HISTORIC AND DESIGN REVIEW COMMISSION

HDRC CASE NO: 2016-132
ADDRESS: 314 DONALDSON AVE
LEGAL DESCRIPTION: NCB 1931 BLK 38 LOT 24
ZONING: R6 H
CITY COUNCIL DIST.: 7
DISTRICT: Monticello Park Historic District
APPLICANT: Nathan Bailes/Gerloff Inc
OWNER: Maria Vargas
TYPE OF WORK: Window replacement
REQUEST:

The applicant is requesting a Certificate of Appropriateness for approval to replace 20 existing wood windows with new wood windows.

INTERIOR of WINDOW: 7

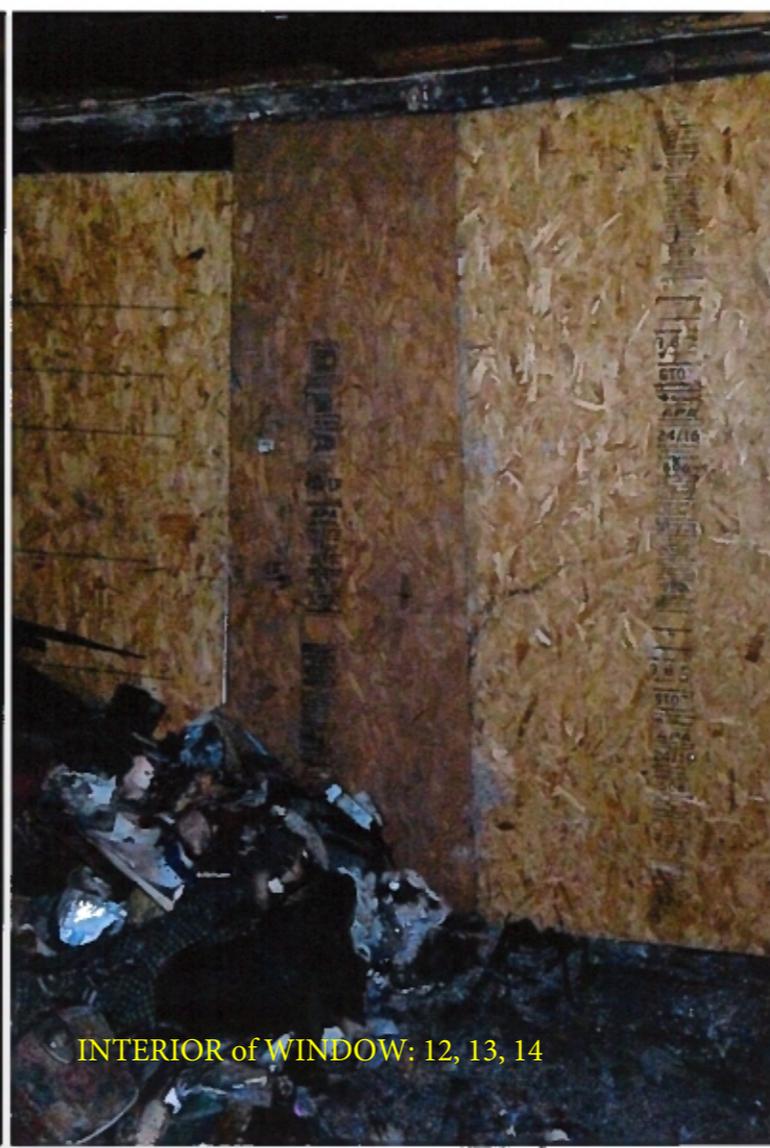
- b. Staff made a site visit on April 12, 2016, and found that the front windows (#1 to 5) are in poor condition, but repairable and covered in metal screens. Staff found that the windows on the left and right facades (#6-11, 19 and 20) were damaged significantly in the fire. Staff finds the proposal to replace the deteriorated windows consistent with the Guidelines and recommends the historic windows #1 through #5 be repaired. The applicant has not provided details of the configuration of the wood windows to be installed, and recommends that the applicant provide to staff prior to receiving a Certificate of Appropriateness. Staff finds a one over one configuration appropriate.

Staff recommends approval with the stipulations that the applicant repair windows #1 through #5, provide specifications on the wood windows to be installed to staff prior to receiving the Certificate of Appropriateness, maintain the original dimension and profile, feature clear glass, and maintain the original appearance of window trim and sill.
